**COMMISSION ACTION FORM**

**REQUEST:** Preliminary Plat – Replat of Outlot A, Grand Aspen 3<sup>rd</sup> Addition

**MEETING DATES:** Planning and Zoning Commission – May 20, 2009

**LOCATION:** 917 South 16<sup>th</sup> Street

PRELIMINARY PLAT  
1. A. H. HARRIS, P.E.  
2. J. H. HARRIS, P.E.  
3. J. H. HARRIS, P.E.  
4. J. H. HARRIS, P.E.  
5. J. H. HARRIS, P.E.  
6. J. H. HARRIS, P.E.  
7. J. H. HARRIS, P.E.  
8. J. H. HARRIS, P.E.  
9. J. H. HARRIS, P.E.  
10. J. H. HARRIS, P.E.

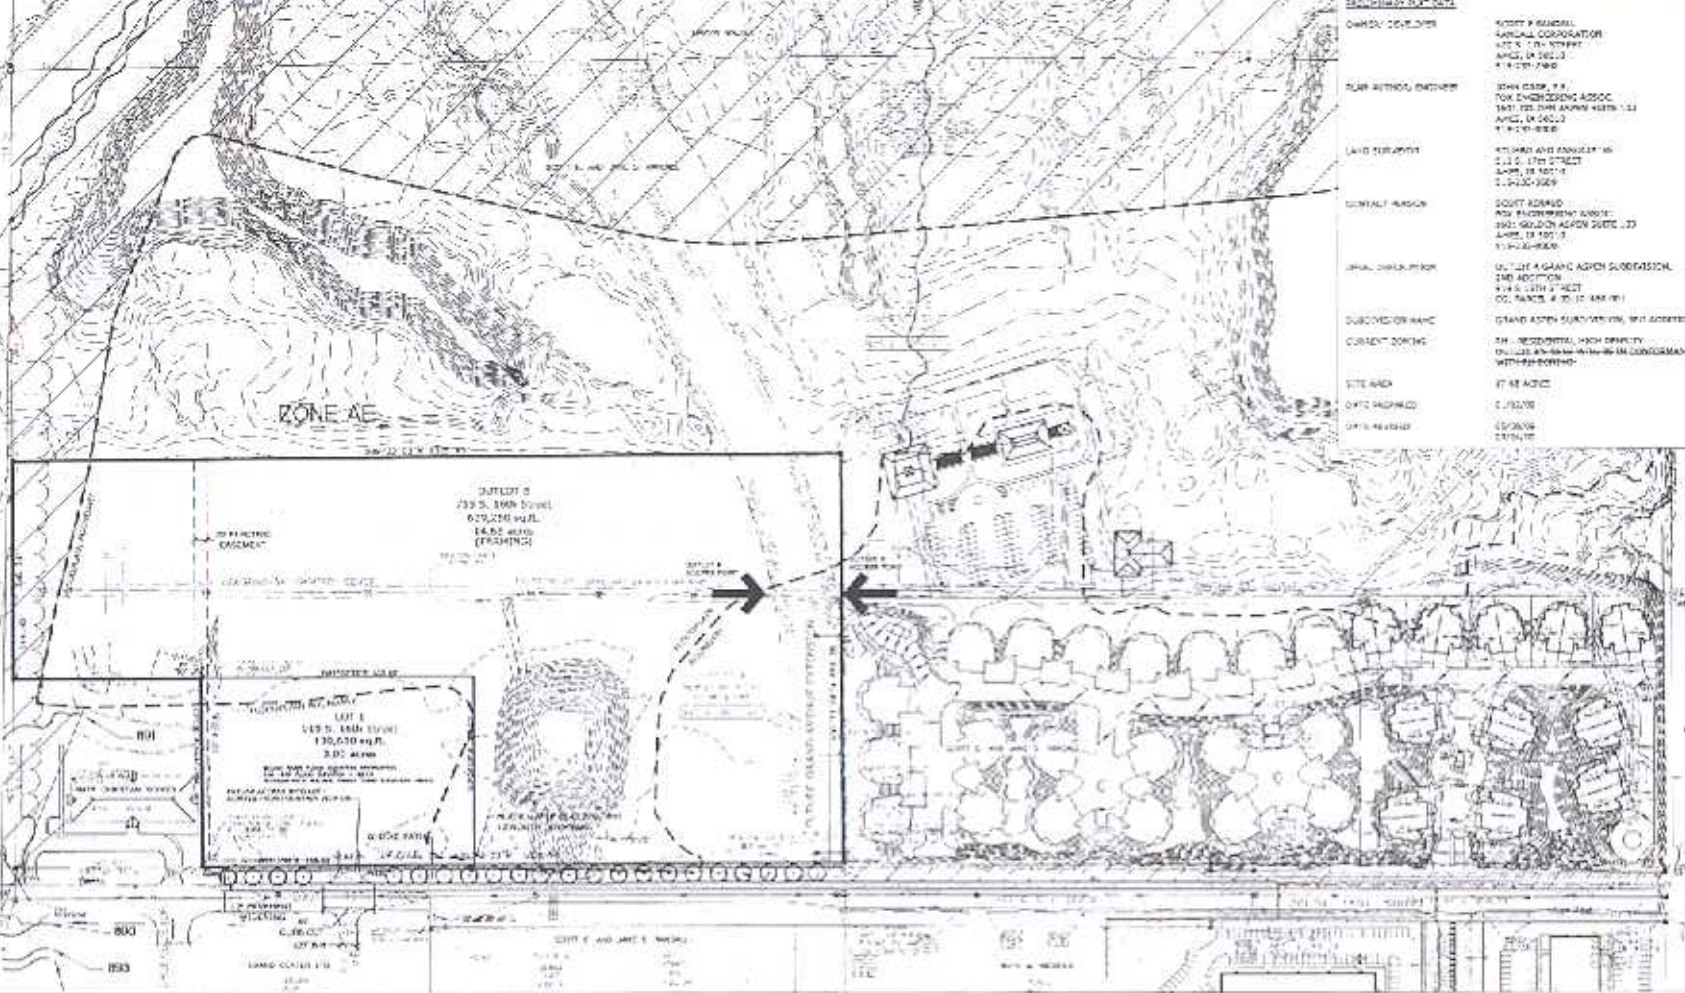
- d. The final plat shall label the identified bike path along South 16<sup>th</sup> Street as a “shared use path”.
  - e. A notation to label the boundary of the “Floodway” shall be added to the preliminary plat before approval.

- f. The statement on the preliminary plat that “Outlot B’s uses will be in conformance with the RH zoning” shall be removed from the preliminary plat Sheet 1 of 2.

- g. A perpetual negative easement shall be shown on the face of the official plat of subdivision, with respect to the south line of the site such that there shall be no access to South 16<sup>th</sup> Street from the site except for one 30-foot intersecting driveway, located directly across from and aligned with Fountain View Drive, to serve as access to Lot 1.
